Application under the *Agricultural Operation Practices Act* for a confined feeding operation, manure collection area, and/or manure storage facility(ies)

<b>NRCB USE ONLY</b>	Application number	Legal land description
	<b>LA25013</b>	<b>N½ 6-11-7 W4M</b>
<input checked="" type="checkbox"/> Approval <input type="checkbox"/> Registration <input type="checkbox"/> Authorization <input type="checkbox"/> Amendment

ERST for **proposed** facilities

Kody Traxel Proposed CFO Figure 1

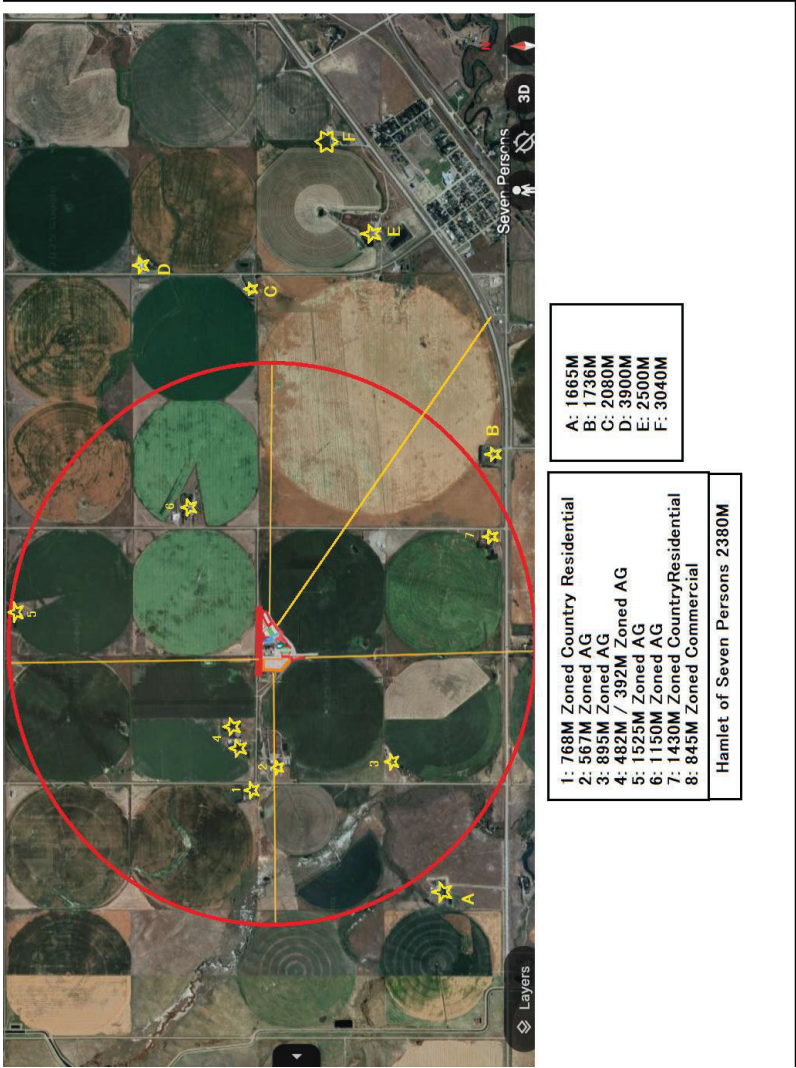
AO Comment: Numbers next to list of neighbours correspond with numbers on map on next page.

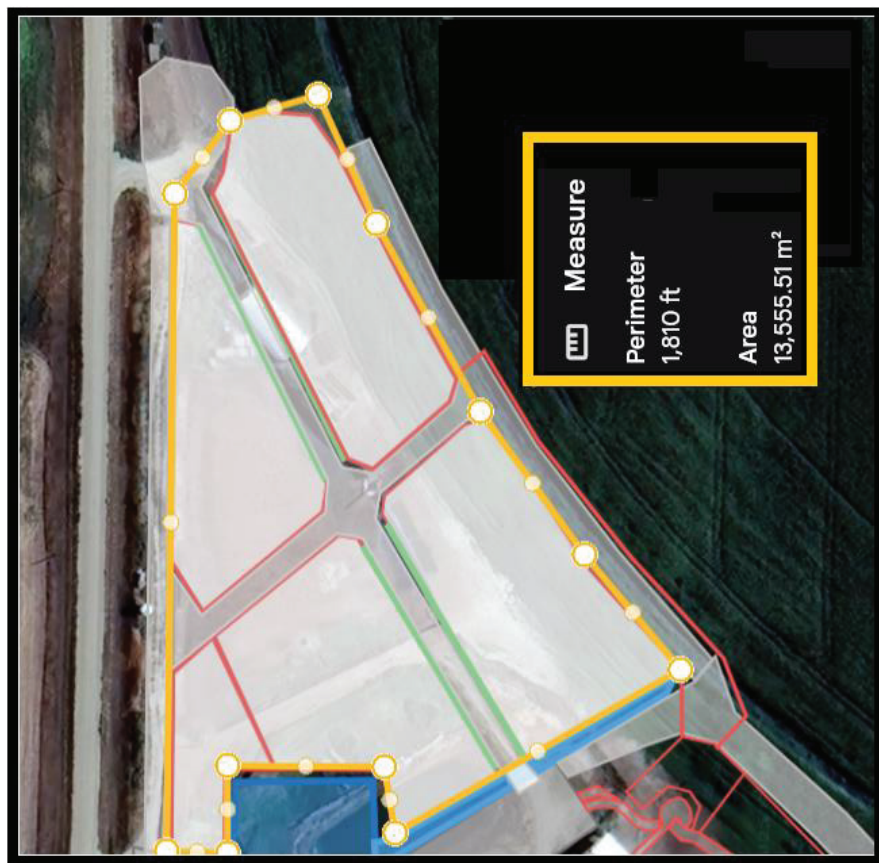
AO Comment: March 20, 2025, JLECS report shows an approximately 7.5 m thick naturally occurring protective layer.

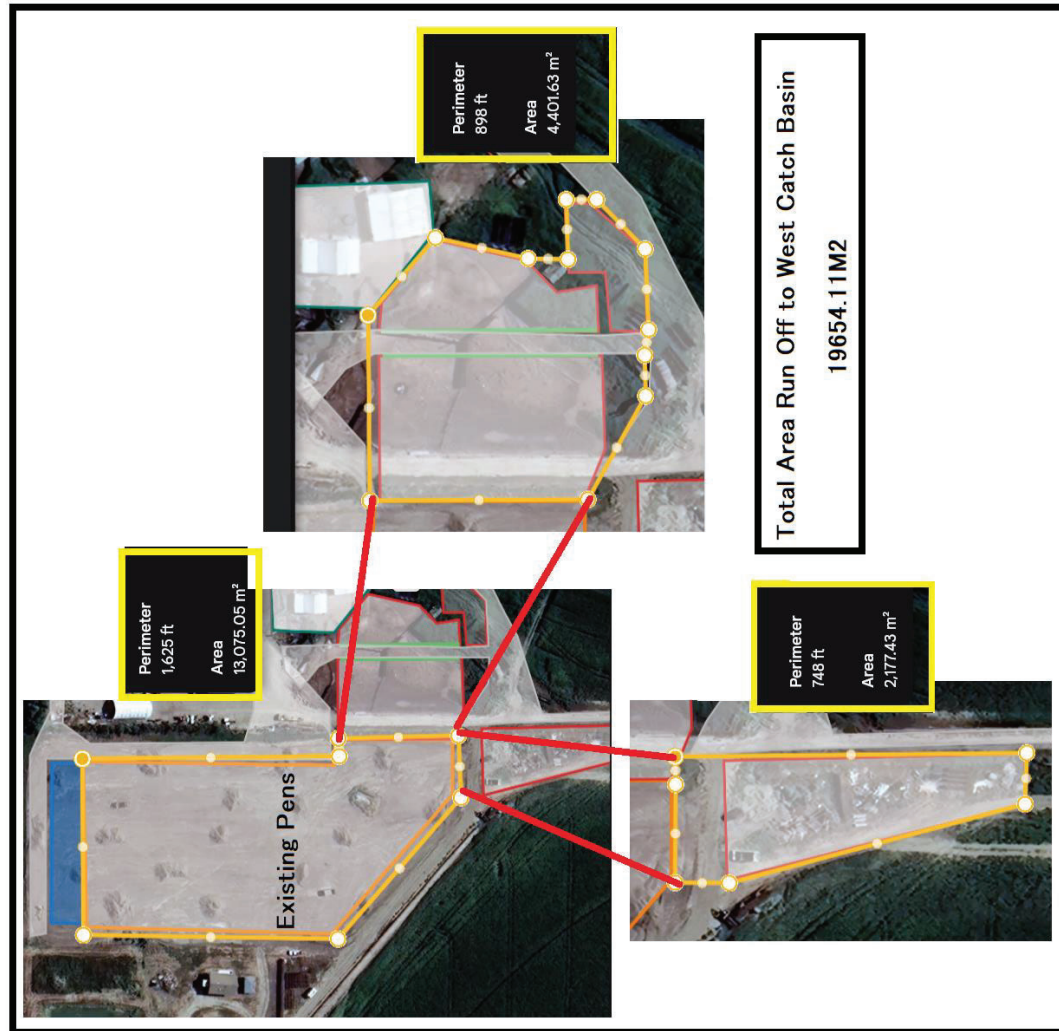
AO Comment: April 18, 2024, JLECS report shows an approximately 7 m thick naturally occurring protective layer.
